## Certificate of Appropriateness for 1811 Regent

March 11, 2019

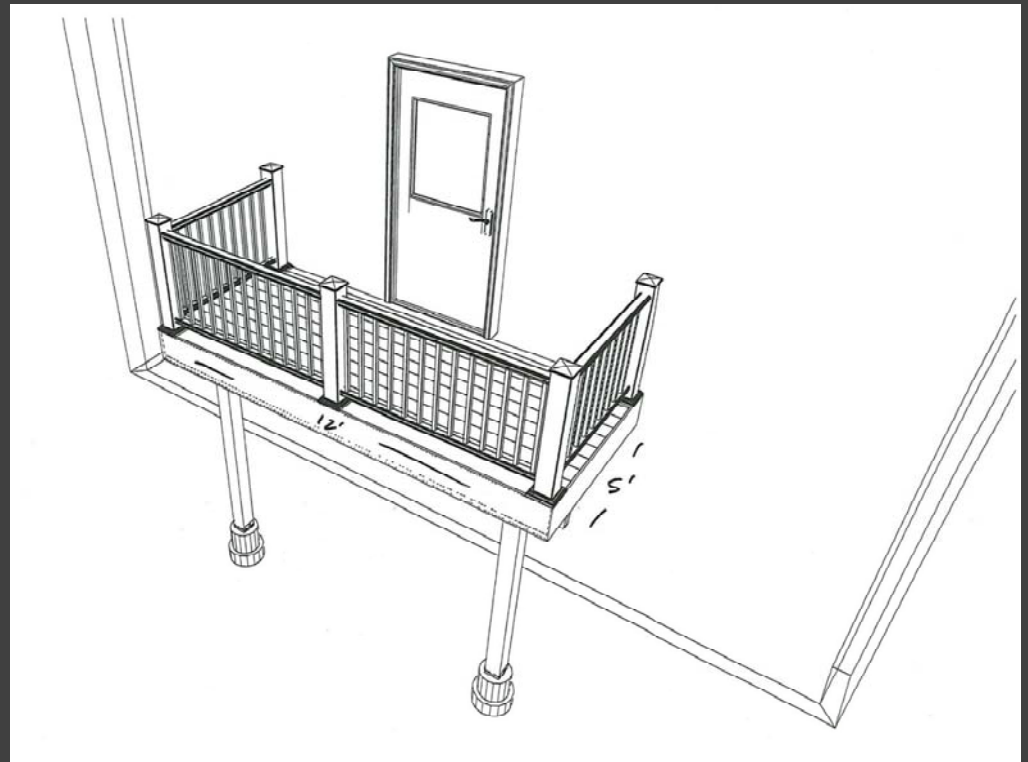
1. Replacement shingle siding must match the existing profile and exposure of the historic shingle siding.
2. The replacement belt band and other trim must be untextured.
3. The replacement basement window must have a three-lite configuration.
4. The balcony must have balusters which replicate the style of the historic balcony; the foundations for the piers cannot be visible above grade; the balcony balusters shall replicate the style of the original; and all replacement materials shall match the trim details of the house.
